**RE: Revised Grading Plan (C-18D012)
American Toyota
Albuquerque, New Mexico**

The purpose of this letter is to accompany the enclosed revised grading plan. The plan has been revised to accommodate your written comments dated 12/23/14. The following is a summary of your comment and the narrative as to how we addressed

REVISED
DRAINAGE REPORT

AMERICAN TOYOTA EXPANSION
Albuquerque, New Mexico

GRADING AND DRAINAGE PLAN

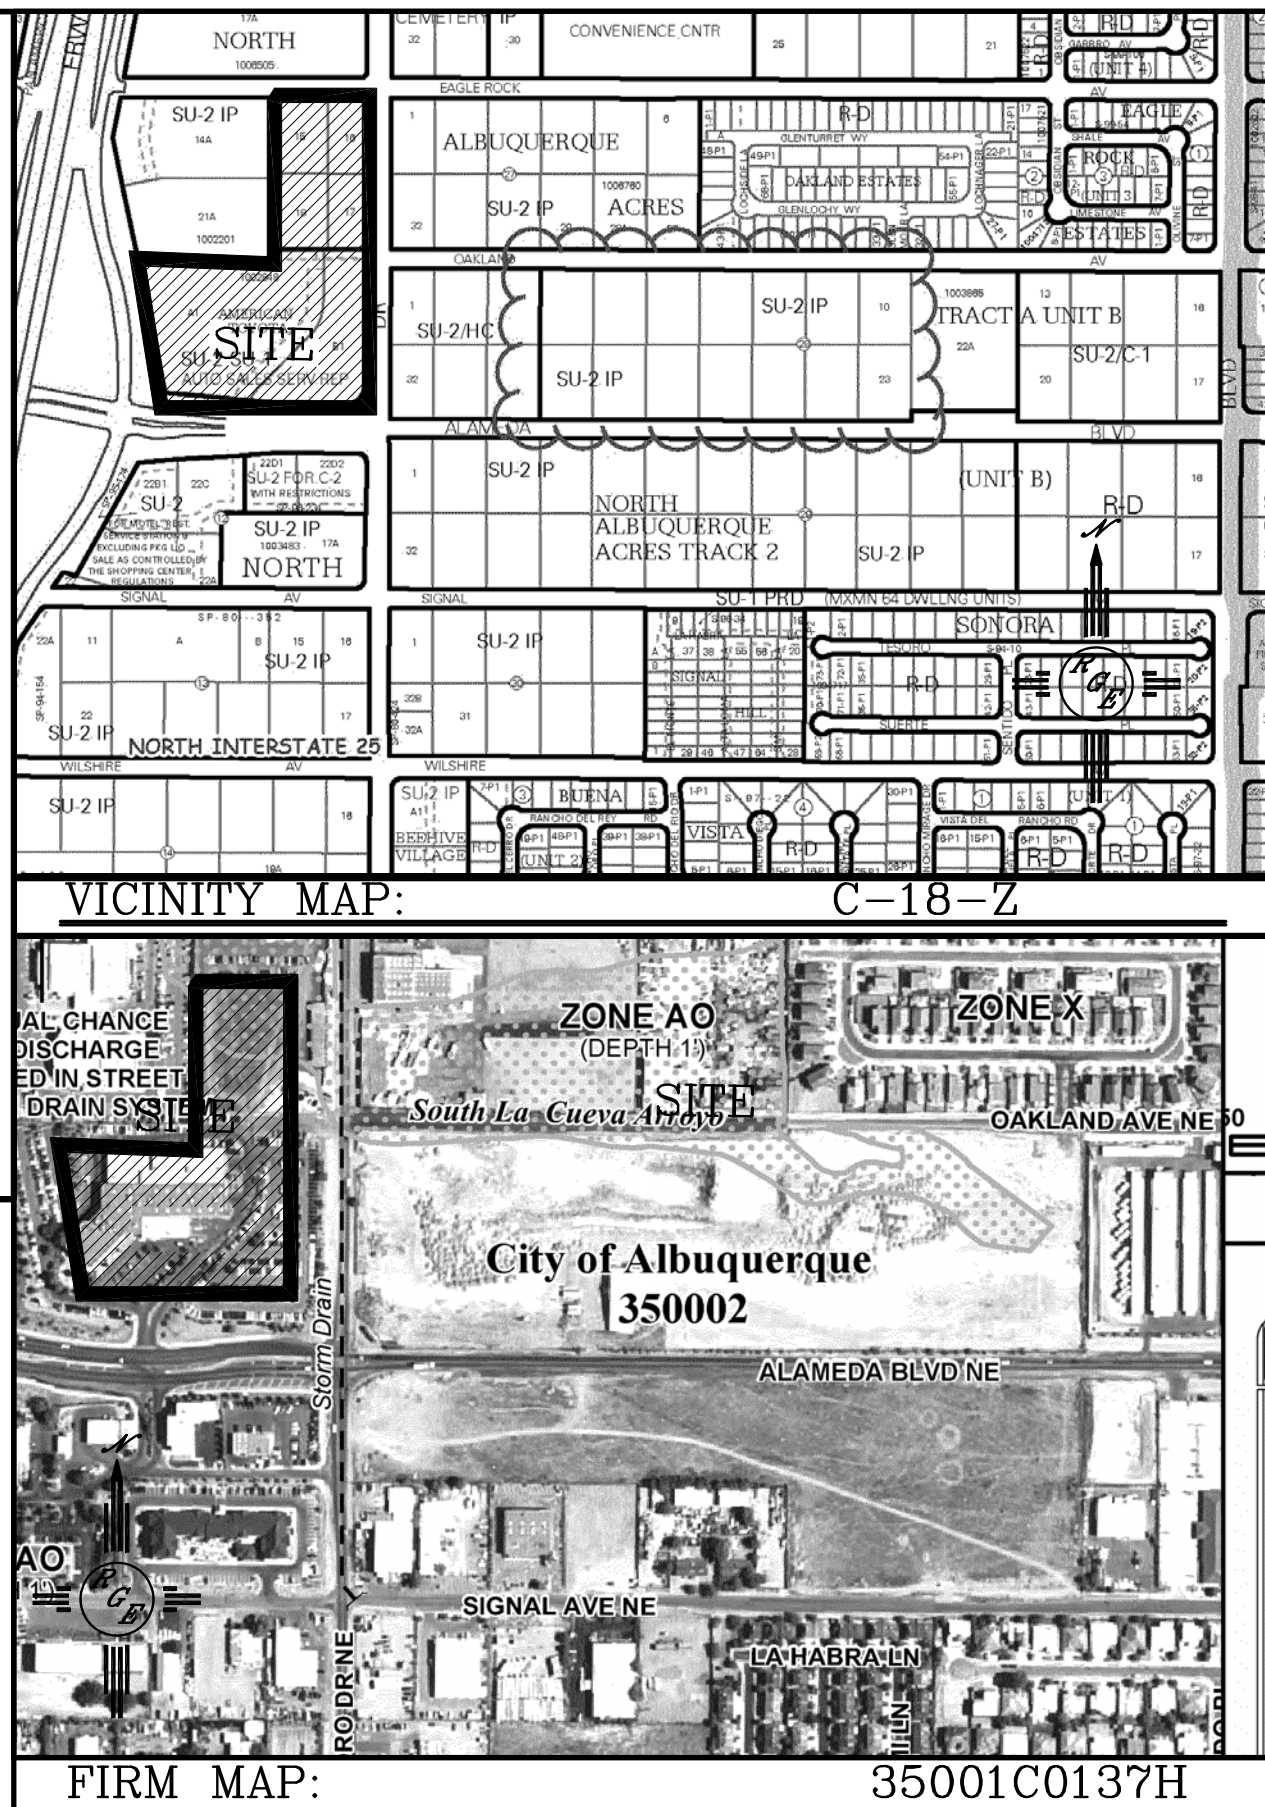
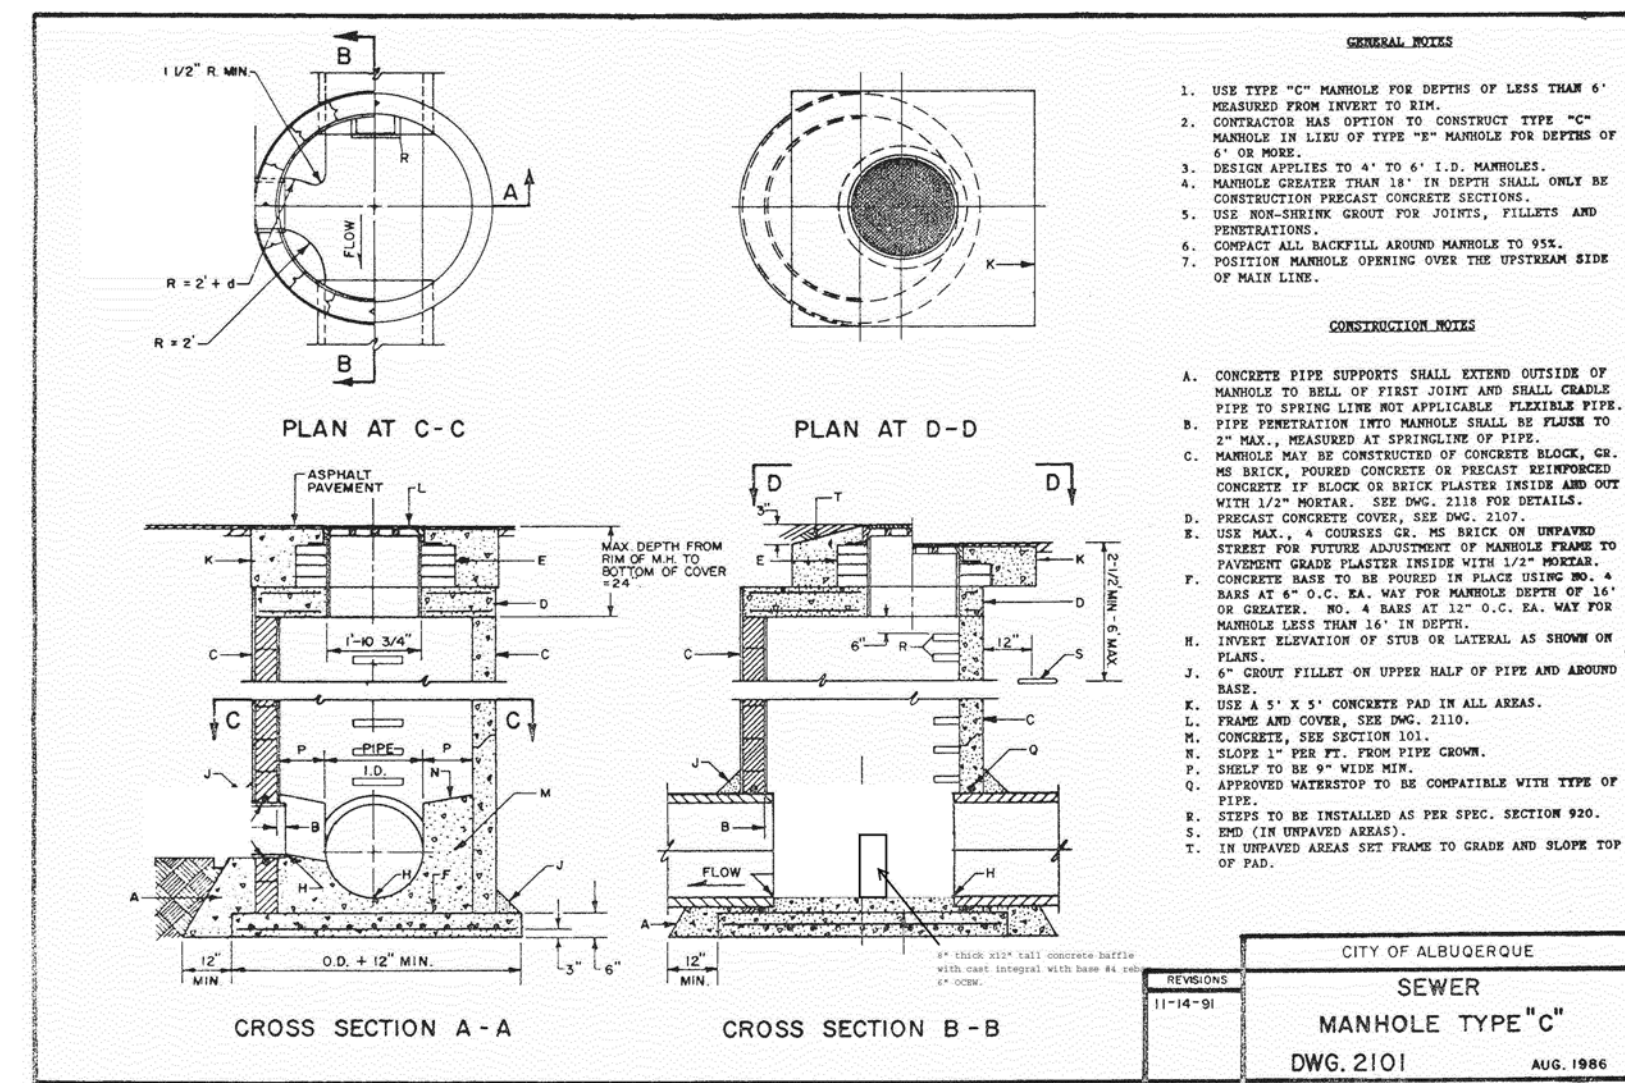
10. In south west corner what is the size of outlet pipe
We have added the size on grading plan
11. In the southwest corner what is size of outlet pip and how will flow go into stormtech and into alameda system
We have added the size of the outlet pipe. The existing pipe will be maintained. A 4' manhole is proposed down stream with a baffle that will force the water into the chambers until they are full then they will discharge to the existing storm drain.

13. In northwest corner what are sizes of pips connection to the system
We have added the sizes of the pipes
14. For north basin will the site no longer utilize existing concrete channel
We will continue to use the concrete channel

17. Show more spot elevations on the wall
We have added additional spots
18. provide electronic copy of report and drawings
We have submitted pdf with this resubmittal
